# Attic New Rev 1

S22-06139  
See 2019 RCO Condition  
Notes Attached

Related to S21-07959 where work on the first floor including relocation of the staircase was conducted. The attic layout is adjusted to the changed location of the staircase. The layout now includes three bedrooms. The windows for the bedrooms have to be replaced to meet egress requirements. The original floor joists were not sufficiently strong and are to be reinforced.

### Section I – Insulation

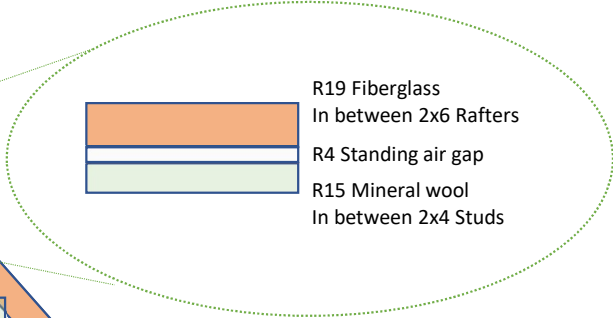
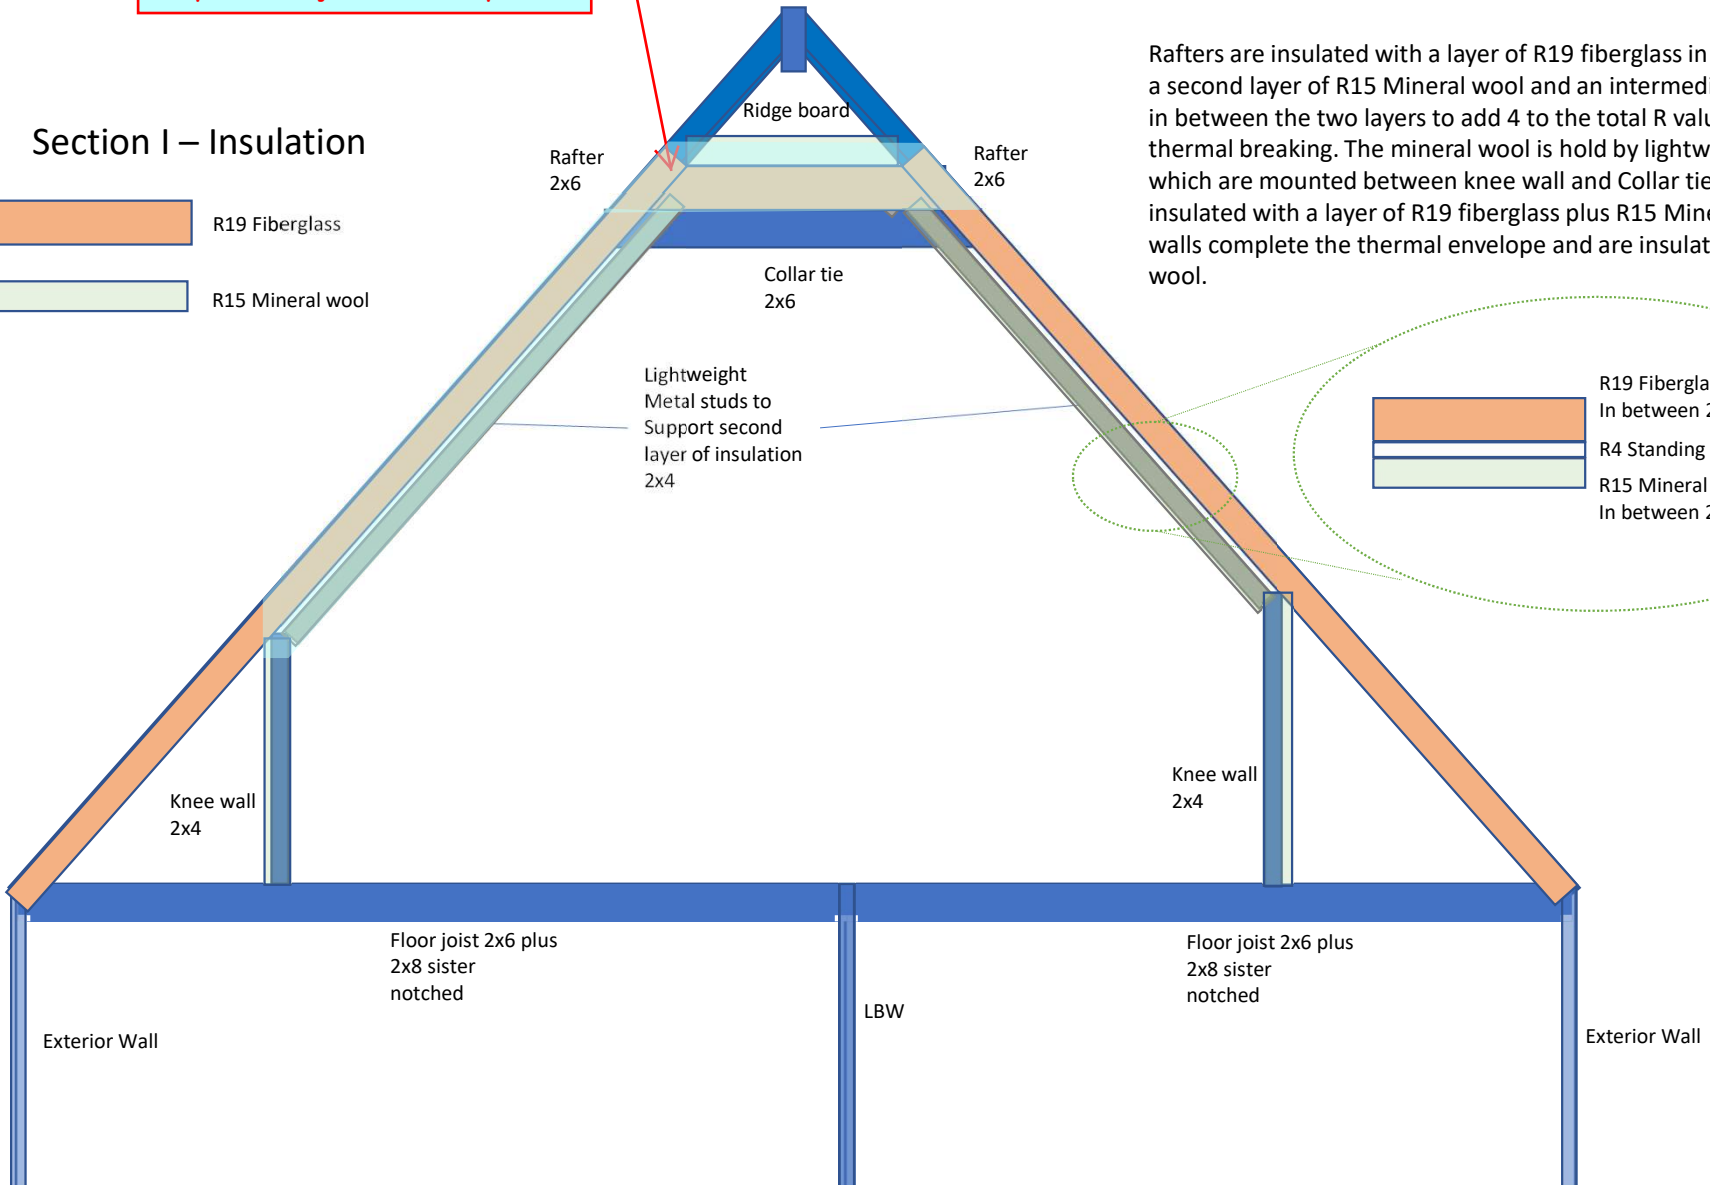
Typ. min. R-49 req'd in attics. In attics with ceilings above a reduction is R-38 permitted if insulation is extended uncompressed over top of wall plate or adjacent roof slope.
